**VIRGINIA ELECTRIC AND POWER COMPANY**  
**NORTH ANNA POWER STATION UNIT 2**  
**REQUEST FOR ADDITIONAL INFORMATION**  
**ASME SECTION XI INSERVICE INSPECTION PROGRAM**  
**RELIEF REQUEST IWE9 CONTAINMENT TESTING**

**Request for Additional Information  
Alternative Test Requirements  
for Containment Repairs**

**Request for Additional Information  
Relief Request IWE-9**

DETAIL FOR LINER PLATE WELDING

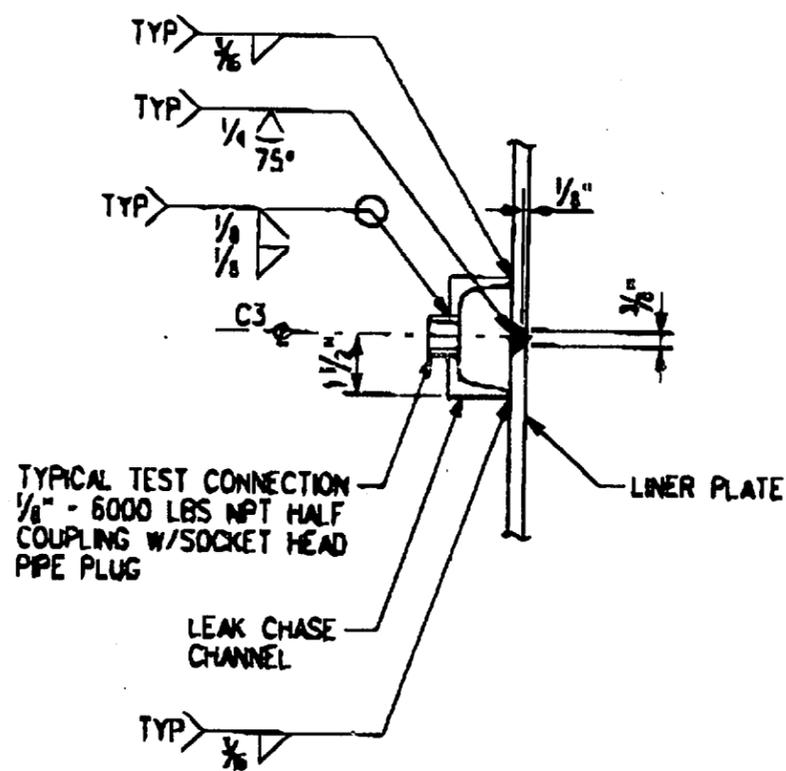
Attachment welds are planned on the metallic liner to create channels for local leak rate testing and for construction aids during liner repair and concrete placement. Please provide more detail and drawings of the channels for the leak testing.

Attachment welds on the metallic liner are required to attach the leak chase channels to the liner. These leak chase channels will be used to perform a local leak rate test of the liner's repair weld. The local leak rate test will confirm the leak-tight integrity of the repair weld and the channel attachment welds.

The enclosed drawings illustrate typical channels and construction aids.

1. Weld the cut section of the liner plate to insitu liner plate, at the temporary construction opening, with full penetration weld.
2. Perform Magnetic Particle Testing (MT) examination of the completed full penetration weld.
3. Perform vacuum box test on the completed full penetration weld.
4. Perform Radiographic Testing (RT) examination of the completed full penetration weld.
5. Seal/fillet weld leak chase channels centered over the perimeter of the full penetration liner plate weld.
6. Perform MT examination of the seal/fillet weld.
7. Pressurize the leak chase channels to 50 psi, and monitor for leakage. Repair leaking welds as necessary, and retest until no leakage is observed.
